Grid Code Consultation B/07 – “Improved Planning Code Data Exchange for Compliance Assessments”

Review of Legal Text following Industry Responses

A Paper by National Grid

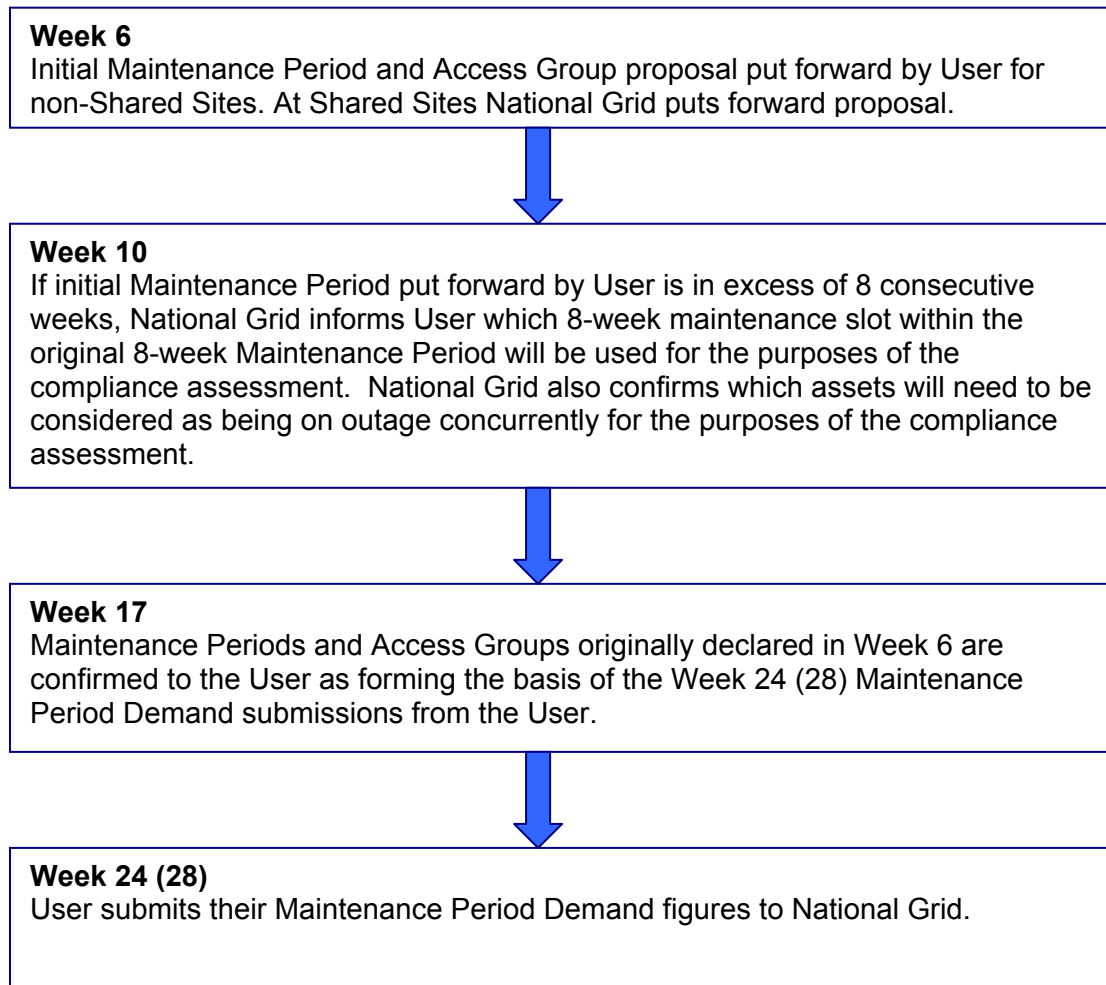
The original aim of the definition was to isolate the assets for which compliance against the Licence Standards are to be assessed. Some respondents have queried whether the definition functions correctly, in particular at Connection Sites where National Grid owns the LV busbars.

In order to address this National Grid considers that a different approach is taken. The new approach rather than attempting to define assets based upon ownership instead defines the assets in relation to their technical function. The revised proposal is that a Transmission Interface Circuit be defined as:

“Transmission Interface Circuit” In NGET’s Transmission Area, a Transmission circuit which connects a System operating at a voltage above 132kV to a System operating at a voltage of 132kV or below; and,

In SHETL’s Transmission Area and SPT’s Transmission Area, a Transmission circuit which connects a System operating at a voltage of 132kV or above to a System operating at a voltage below 132kV

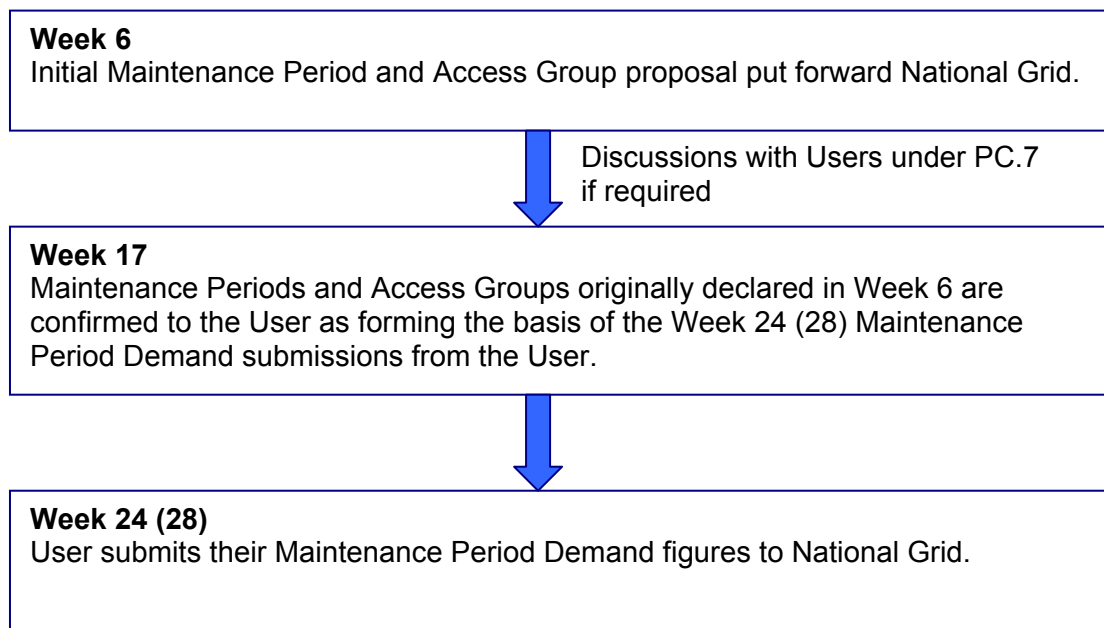
A number of comments were made upon this process with some respondents feeling that the process was in some cases inappropriate. The bulk of concerns surrounded:

- The fact that a User may not be in a position to identify the Maintenance Period by Week 6 even for non-Shared Sites and the fact that a User is expected to devise the Maintenance Periods in some User's views means that the User is expected to perform a GB SQSS compliance assessment.
- The fact that at Shared Sites National Grid would not be able to meet its Week 10 obligations as currently drafted regarding notification of assumed concurrent outages
- That the Week 10 process and the associated Maintenance Period and maintenance slot terminology is potentially confusing

Given respondent's concerns National Grid proposes a revised streamlined approach be taken in relation to the week 6 to week 17. The key features of this revised approach would be:

- The Week 6 process would now see National Grid put forward the initial Maintenance Period Proposal for all Sites. This Maintenance Period would now be a continuous period of 8-weeks between weeks 13 and 43.
- The Week 10 process would now be redundant and so is removed from the process.
- Following discussions with Users between week 6 and week 17 National Grid would then confirm the Maintenance Period for which a Maintenance Period is to be declared in Week 17.
- Users would submit their Maintenance Period Demands for the relevant Maintenance Periods in Week 24 (28).
